REEVES TOWNHOUSES – RESPONSE TO DISCRETIONS
5 EGLINGTON STREET, SOUTH LAUNCESTON 7250

Thank you for the opportunity to respond to the discretions that you have identified after public advertising of my Development Application DA0252/2018 at 5 Eglinton St, South Launceston, the scope of which is:

Figure 1

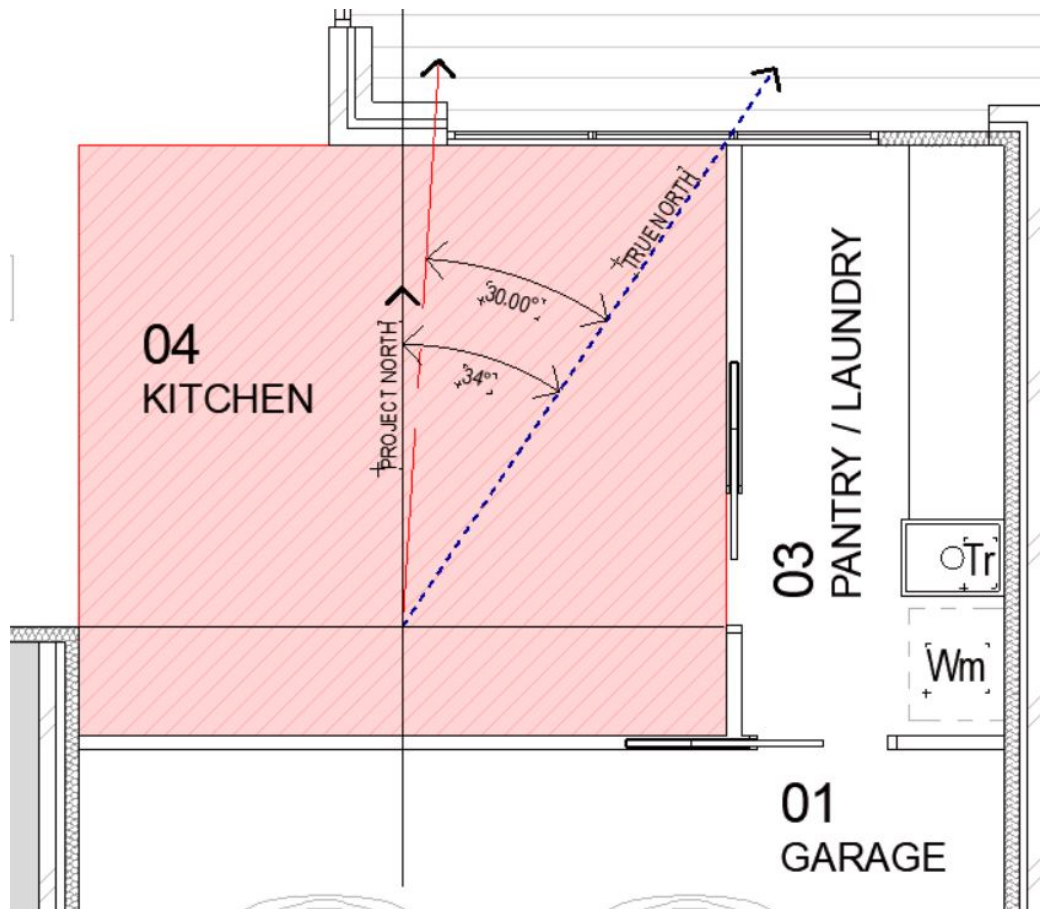
A1. The north arrow on the site plans appears to be inaccurate and based on the orientation the north-western boundary the living room windows of dwelling 1 and the kitchen window of dwelling 2 face approximately 40 degrees west of north.

This discretion is correct. The discrepancy relating to the north arrow has been corrected and the kitchen window of dwelling 2 will face 34° west of north (refer to Figure 1). This is outside the range required by the AS.

The glazed sliding door and adjacent windows to the open plan living area will allow sunlight to enter the room.

The performance criterion is met.

Figure 2

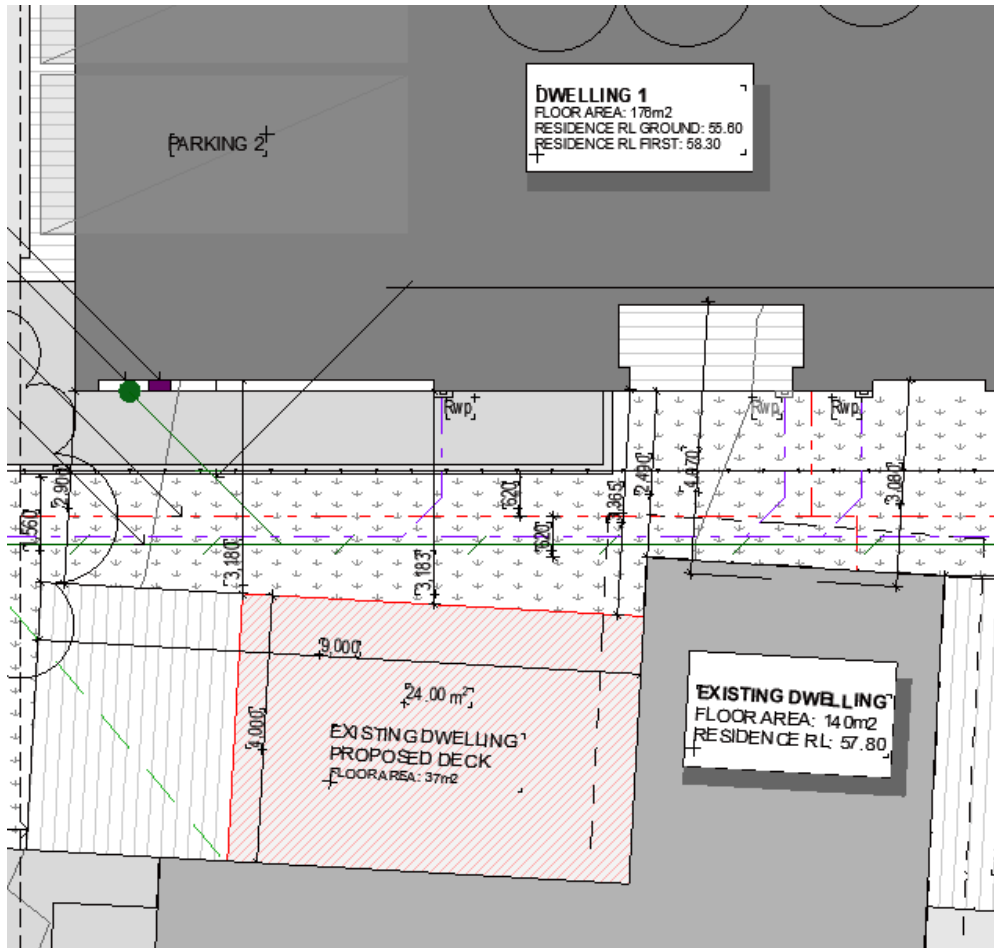
A3. The private open space of the existing dwelling is within 3m of dwelling 1, which is located to the north. The private open space of the existing dwelling is not 50% free from overshadowing for 3 hours of the 21st of June.

This discretion is incorrect.

The acceptable solution states that the relevant area of private open space to which the clause applies is the private open space required in accordance with standard 10.4.3 (A2) or (P2).

The existing dwelling will be provided with an area of private open space that complies with clause 10.4.3 (A2). The private open space will be integrated into the western deck and is illustrated by figure 2.

It is evident from figure 2 that dwelling 1 will be setback a minimum of 3m from the area of private open space designated for the existing dwelling. Further, the portion of dwelling 1 equal to and above the finished floor level of the private open space of the existing dwelling, will be located within the envelope which is determined by subclause (a) (ii).

Acceptable solution 10.4.4 (A3) (a) is therefore met.
